STORM WATER REPORT

Cobey Creek
Mixed Use Development
Lee's Summit, MO

1. Original Storm Report-May 22, 2018
2. Addendum 1- July 1, 2019- Effective Height and Energy Dissipation additions to North Pond
3. Addendum 2- August 3, 2020- Updated South Pond Outlet Structure-Pond Pack Print out.
4. Addendum 3- October 8, 2020- Approved Outlet Structure Geometric Changes from Circular to Square and Rectangular

Addendum 3
Cobey Creek
Mixed Use Development
Lee's Summit, MO

STREET AND STORM SEWER PLANS
NORTH DETENTION BASIN
OUTLET STRUCTURE

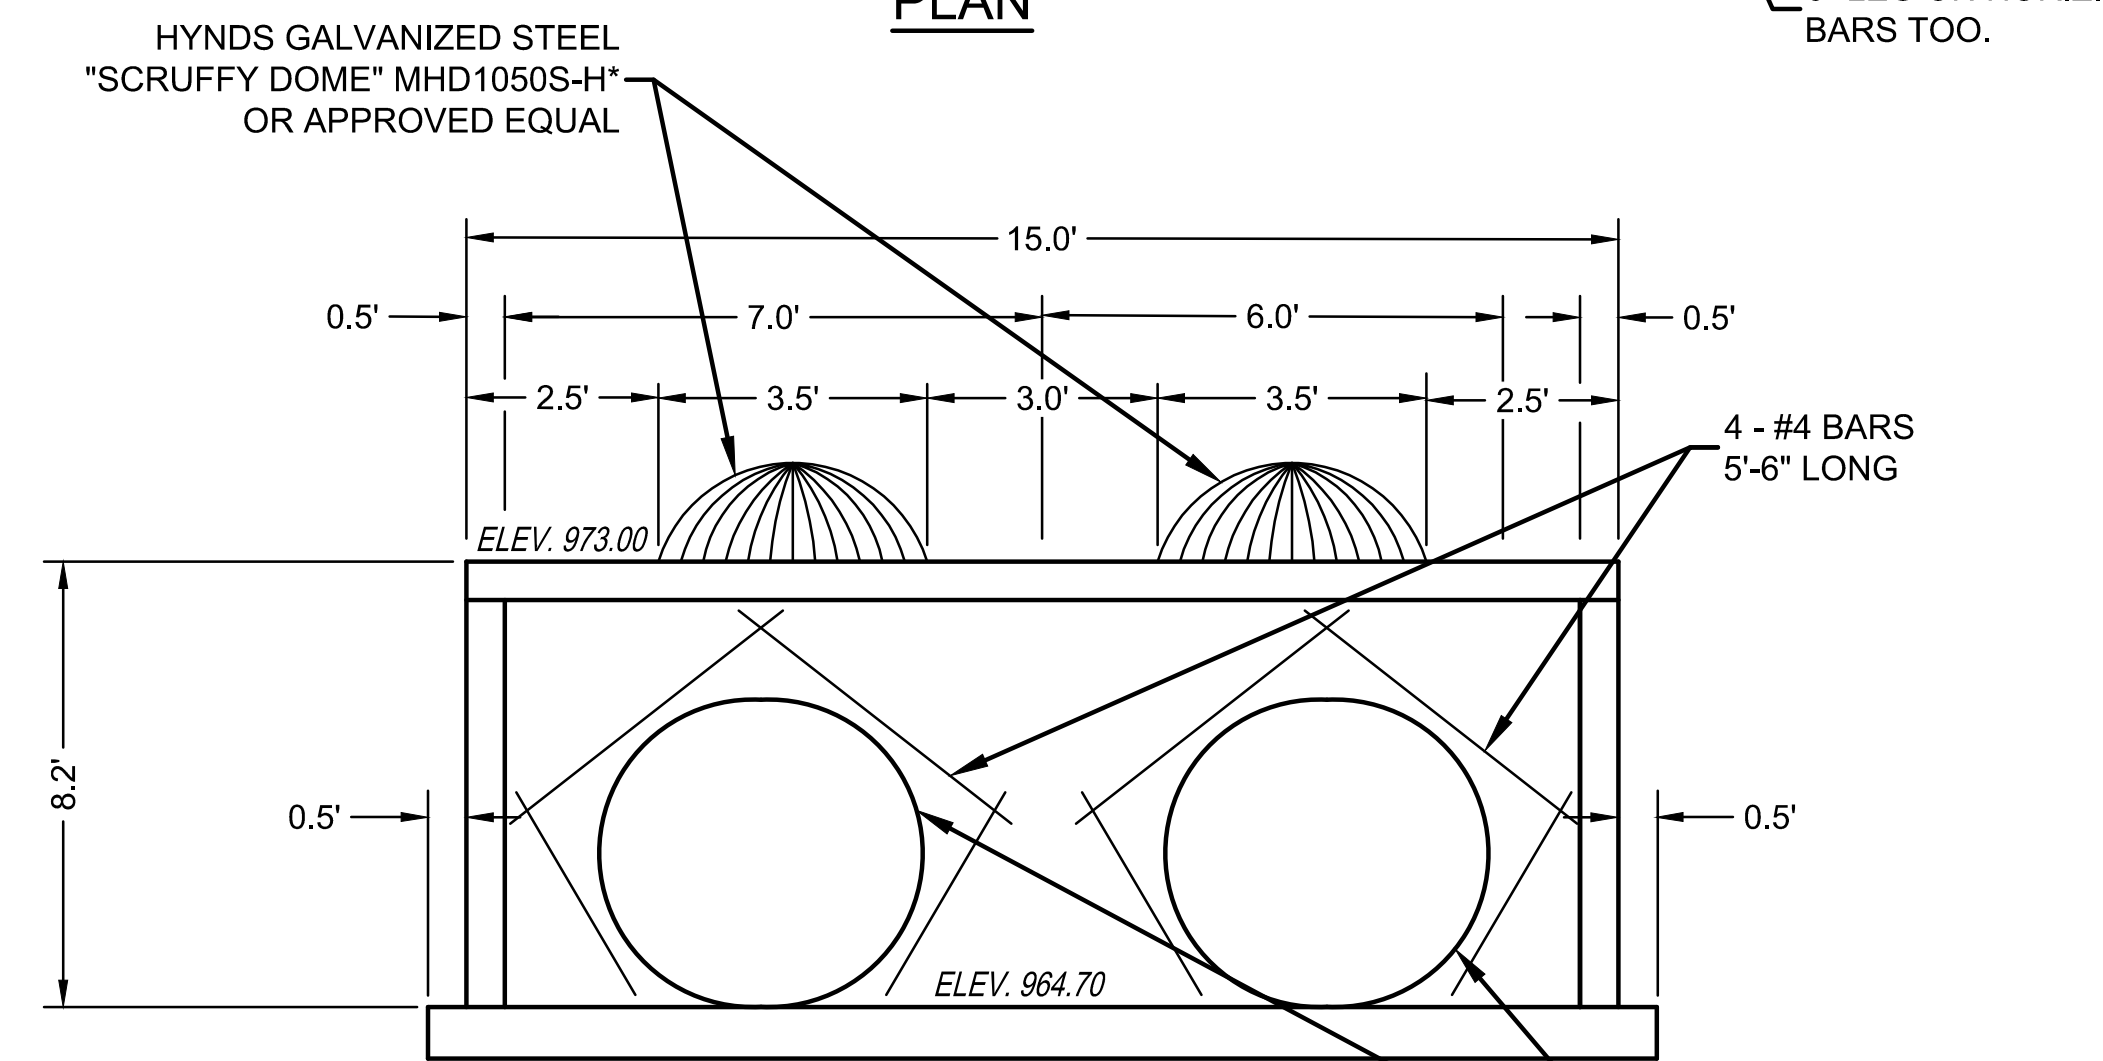
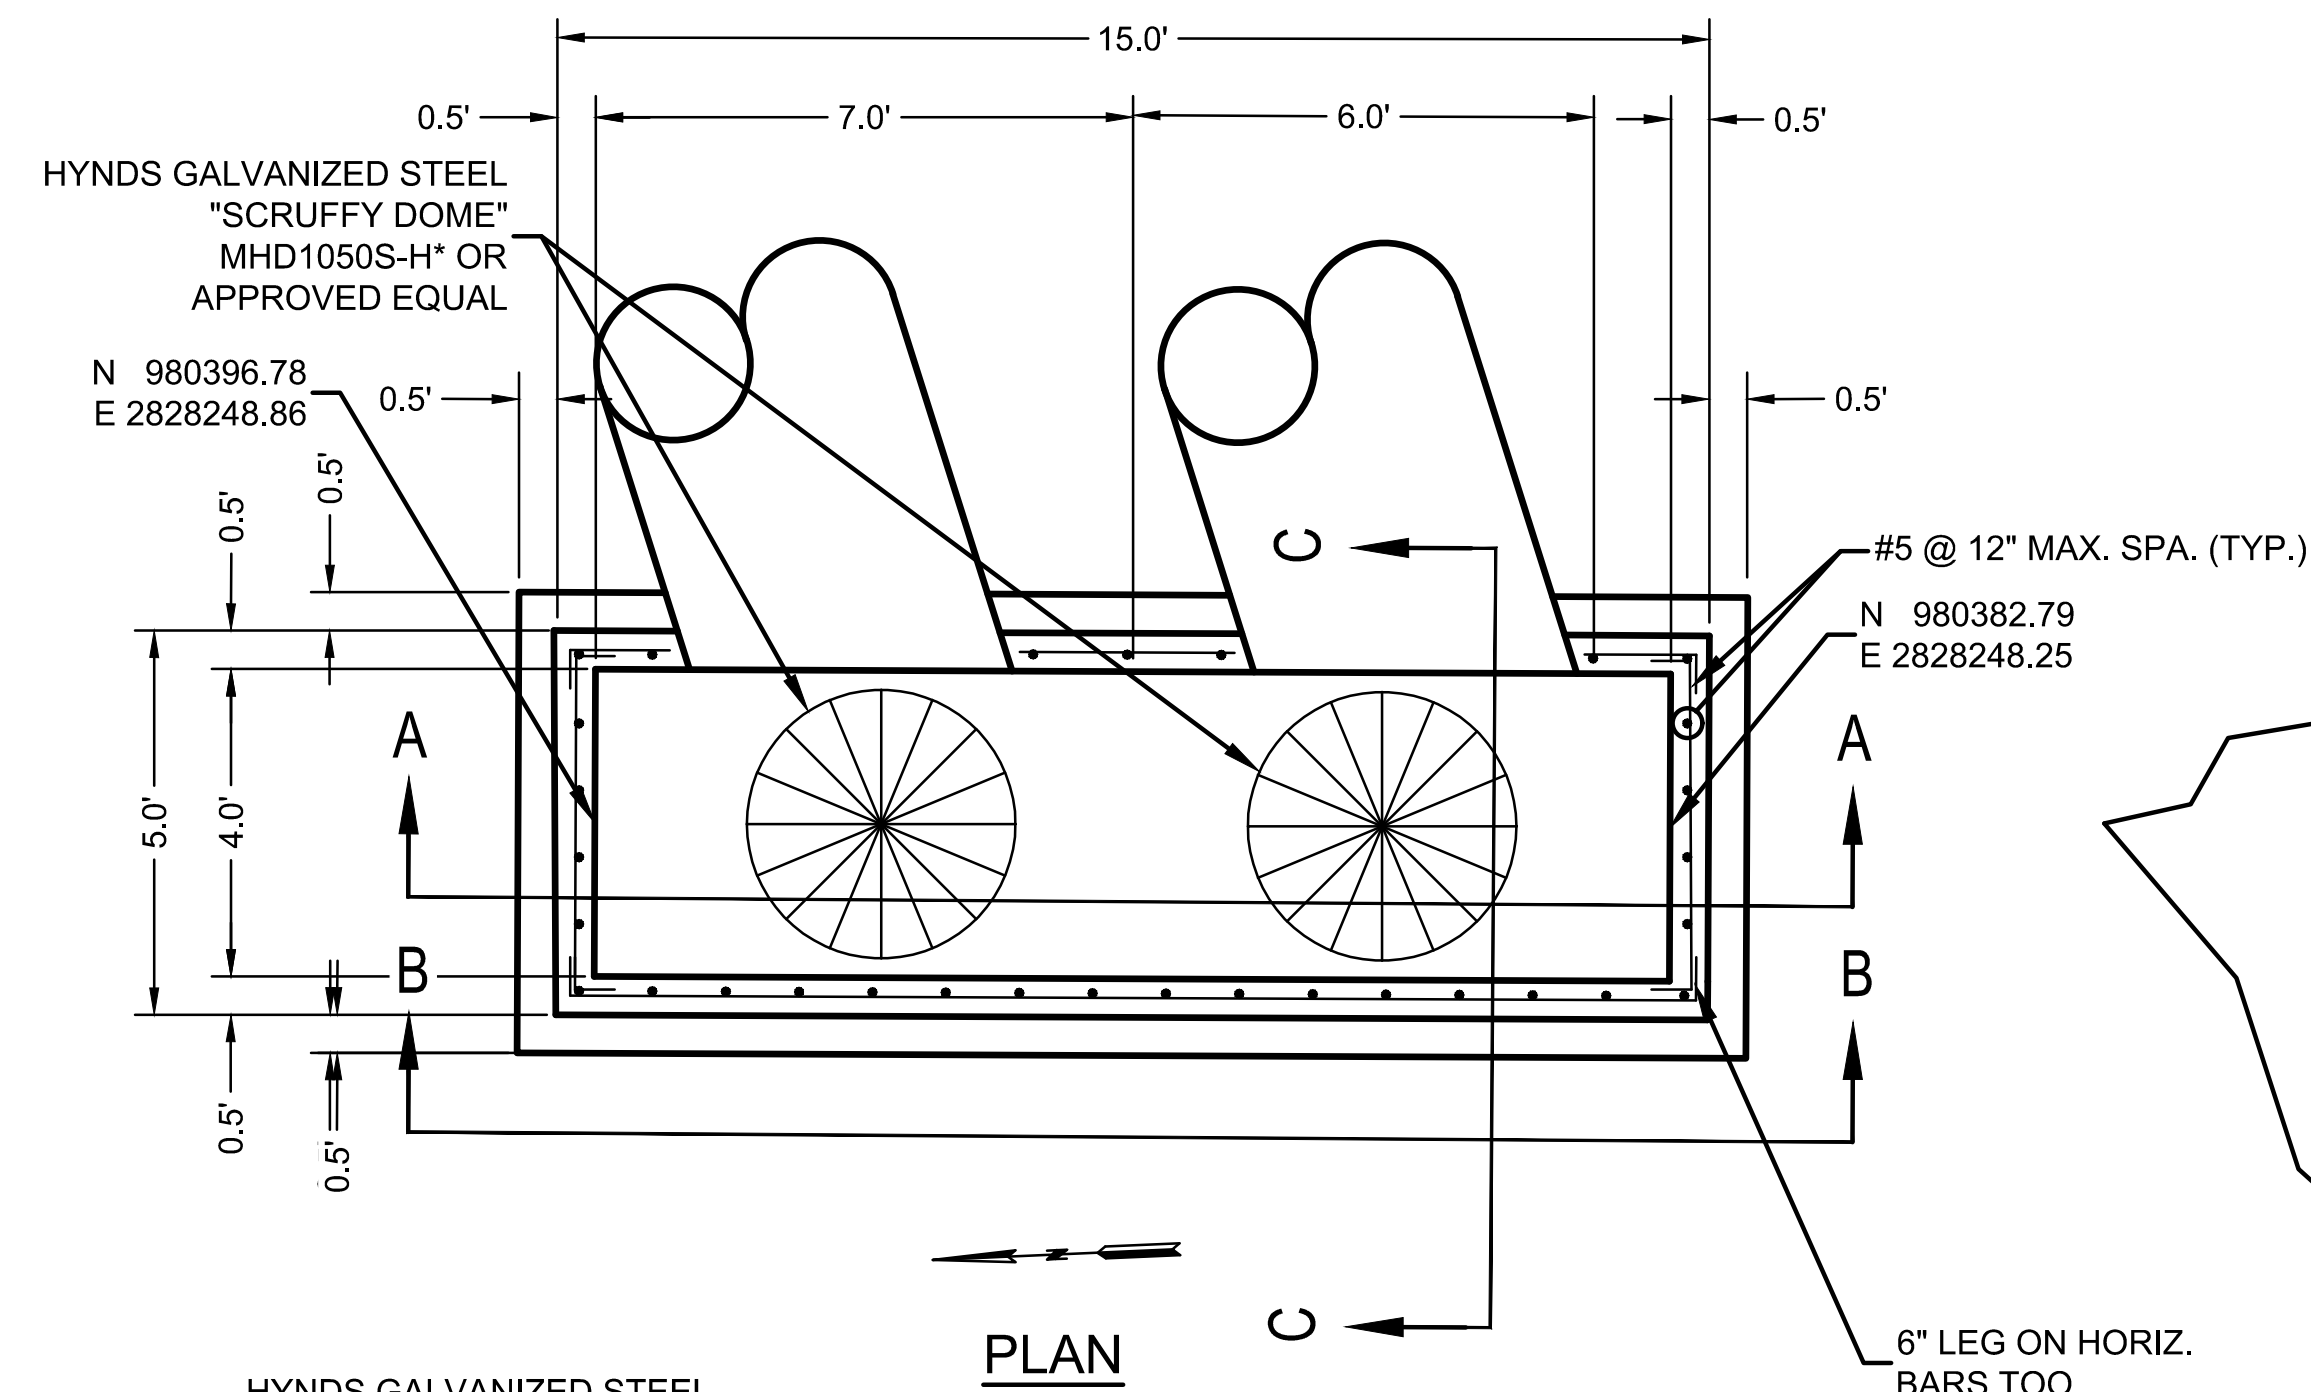
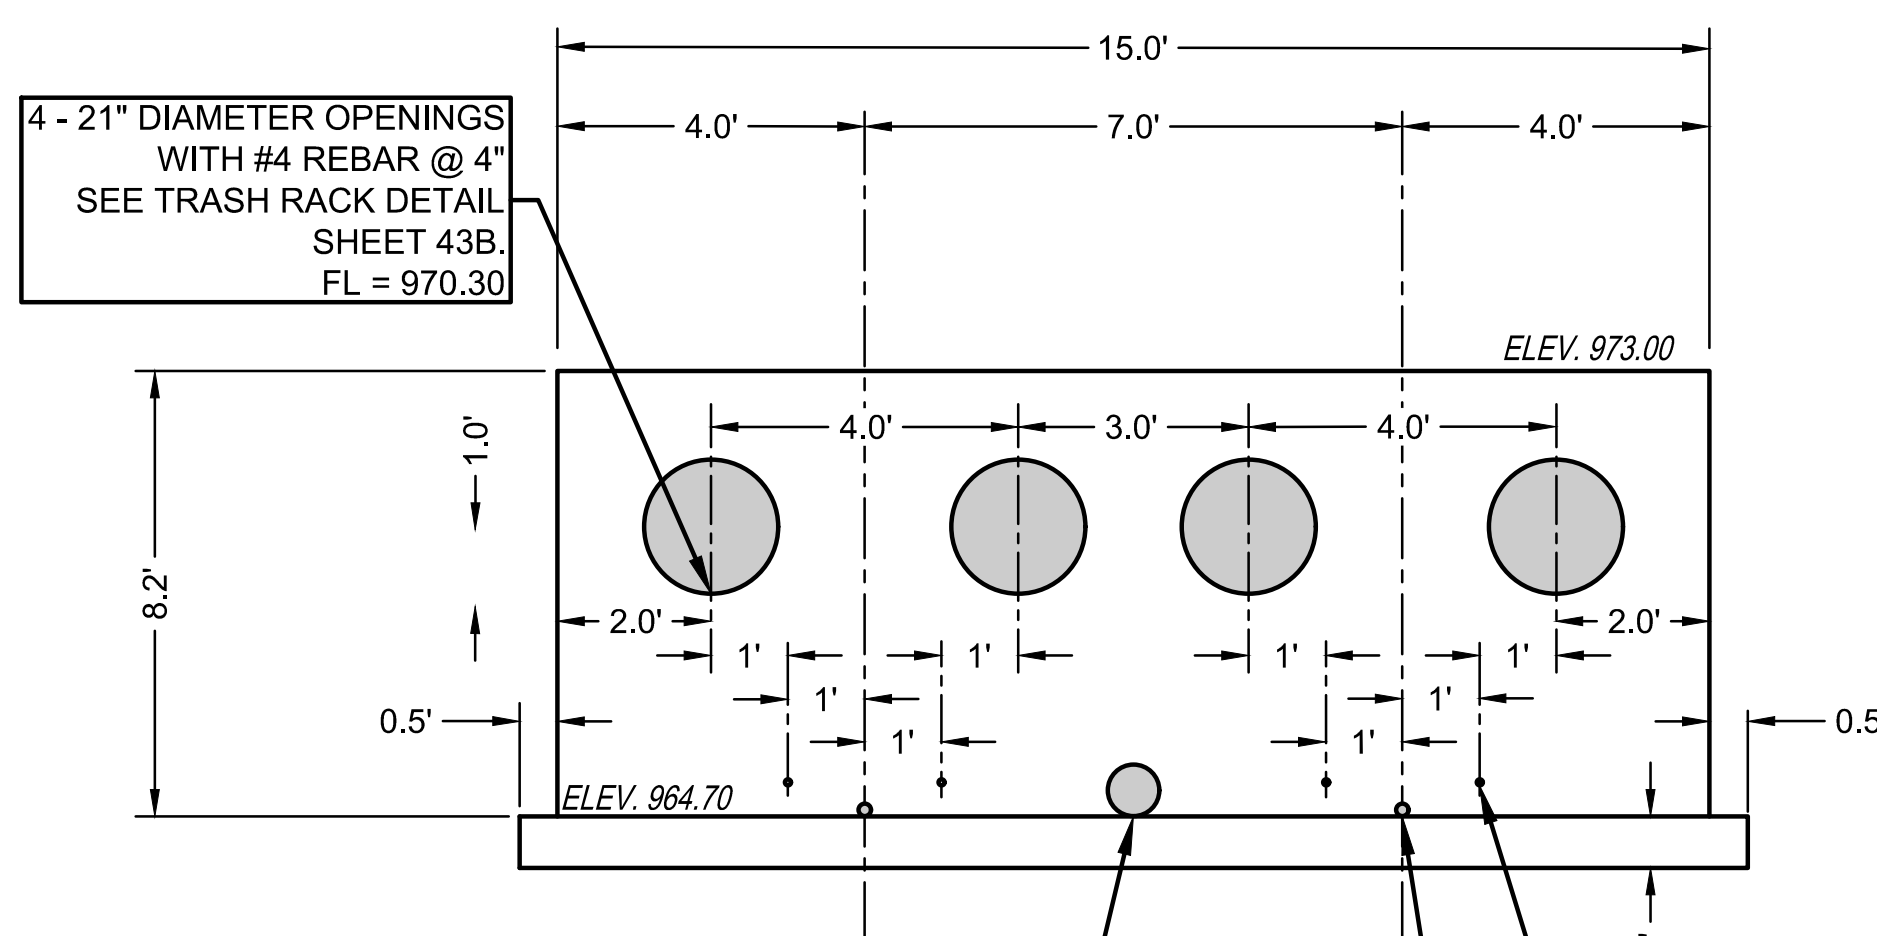
This addendum to the Final Storm Report for Cobey Creek, Phase 1 is prepared for addressing the change to the geometric shape of the outlet structure in the north pond from circular to rectangular, due to the unavailability of a six foot diameter manhole.

This change is the same as the change at the south pond, except that the north pond design called for 2 circular manholes side by side. The shape of the outlet structure has been redesigned to incorporate the 2 manholes into one larger and rectangular structure. All orifices that were shown for the manholes have been incorporated into the rectangular structure at the same elevations to provide the same hydraulic flows at the various storm events as originally designed. Details of the new and approved structure are attached.

The approved outlet structure in the north detention pond is 2- 6' diameter manholes with the accompanying orifice openings and pipe sizes and locations shown. Due to the inability of the local precasters to provide a manhole of the diameter required, an alternate shape of structure is needed.

It is proposed that in lieu of the 2- 6 diameter manholes, a single 5' x 14' rectangular concrete box be used, to provide the same function.

As detailed, the rectangular concrete box will provide the same orifice opening sizes, elevations and domed grates as the approved manholes, with no changes in the hydraulic function of the structure or pond from the approved version of the plans and storm report.

Upon approval, the contractor intends to cast the box in place per the detail and in the location shown on the detention plan.
